**Vogtle Electric Generating Plant – Units 1 and 2  
Request for Additional Information Response Regarding  
Proposed Inservice Inspection Alternative VEGP-ISI-ALT-07**

**SNC Response to NRC RAI Regarding VEGP-ISI-ALT-07**

FIGURE RAI #1-1a TYPICAL CONFIGURATION OF VOGTLE UNIT 1 CRDM NOZZLES 1 THROUGH 78 AND VOGTLE UNIT 2 CRDM NOZZLES 74 THROUGH 78 AS DEPICTED ON FIGURE 2 OF CODE CASE N-729-1 NOT TO SCALE

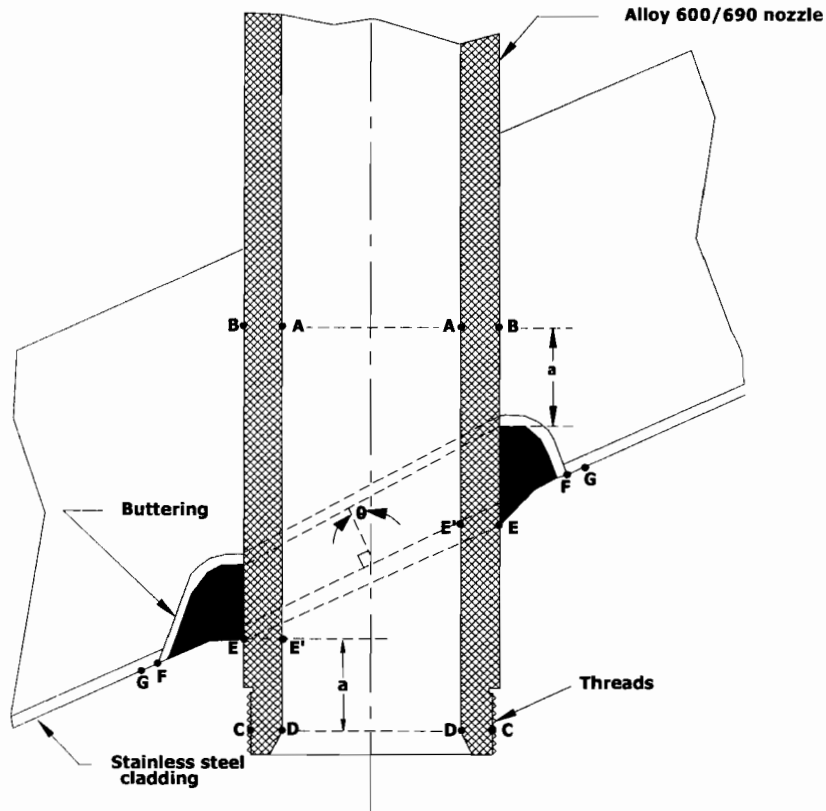
The licensee referenced Figure 2 in ASME Code Case N-729-1 for the examination of the reactor vessel head nozzle penetrations. It appears that the penetration at Vogtle is slightly different from Figure 2 of N-729-1 in that the lower region of the Vogtle penetration nozzle is threaded. Figure 2 of Code Case N-729-1 uses alphabetic letters to identify specific areas/regions of interest for the J-groove weld and nozzle. The relief request discussed the following areas/regions of interest: the bottom of the fillet, the toe of the J-groove weld, chamfered regions, regions having a radius, the distance between the lowest point at the toe of the J-groove weld and the bottom of the scanned region, the proposed alternative examination zone, incidence angle, thread sections, thread relief, and shadow zone in the threaded region. It is not clear to the staff how these terms relate to the "lettered" dimensions in Figure 2 of ASME Code Case N-729-1. (a) Please provide a drawing(s) of a typical control rod drive mechanism penetration nozzle showing the threaded region with a tapered inside surface at the bottom of the CRDM nozzle. (b) In the drawing, please identify the items that correspond to the letters used in Code Case N-729-1 and to the areas/regions mentioned in the relief request.

Southern Nuclear (SNC) is providing four sketches to provide additional details for the actual configuration of the nozzles. Figure RAI # 1-1a shows the configuration of the Unit-1 CRDM nozzles 1 through 78 and the Unit-2 CRDM nozzles 74 through 78. Also enclosed is Figure RAI # 1-1b which provides the details of the threaded/chamfered nozzle end (Type X). The toe of the weld is located above the reduced cross section. Figure RAI # 1-2 shows the configuration of the Unit-2 CRDM nozzles 1 through 73. In addition, Figure RAI # 1-3 shows a top view of the Units 1 and 2 reactor pressure vessel (RPV) head CRDM configuration in order to show the relative location of the CRDMs. Figures RAI # 1-1a and 1-2 were generated from Figure 2 from ASME Code Case N-729-1 to help identify the required examination volume and the physical limitations. The coverage lengths listed in Tables 1 and 2 of the proposed ISI alternative corresponds to the "a" dimension (below the J-groove weld) identified in Figure 2 of ASME Code Case N-729-1.

- a) Table RAI # 5-1 shows the twenty-two Vogtle CRDM penetration nozzles included in this ISI alternative. The two sections of the table show the initial thirteen nozzles and the nine additional nozzles. The alternative examination zone extends from the toe of the weld down the nozzle for the dimension identified in Table RAI # 5-1, as noted in the column listing "a". This is the "a" dimension below the weld shown in Figures RAI # 1-1a and RAI # 1-2 added to address RAI question # 1.
